[SAFETY RECALL – OWNER NOTIFICATION LETTER]

RE: Model APX9-1000 and APX9-1200 Dry bulk trailers with Aluminum Endframe Option, Serial numbers [list serial numbers here as they apply to each individual customer.].

OWNER NOTIFICATION – ILLUSTRATION OF DEFECT

Figure A: Front Frame

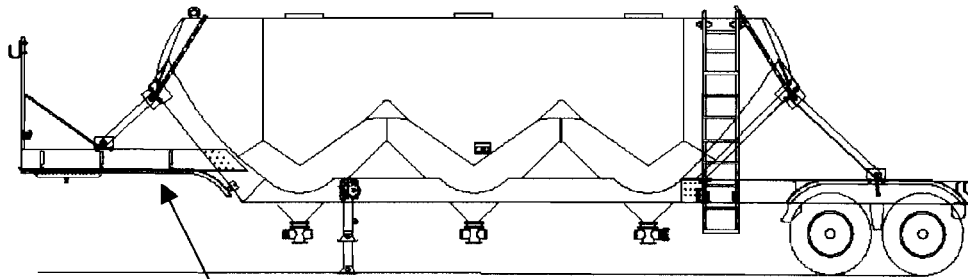
A crack may develop in the right front frame rail of the front frame, and eventually propagate through the frame.

Figure B: Crack Location

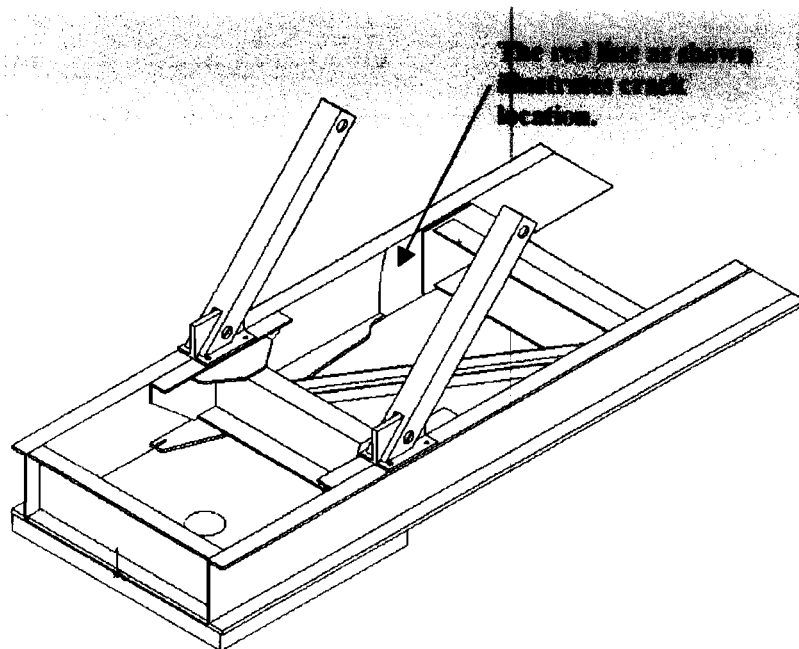
This occurs because a small crack may start at the termination of a welded gusset, and propagate over time. If undetected, the crack will grow to the point of failure. See Figure B for a detail of the crack location.
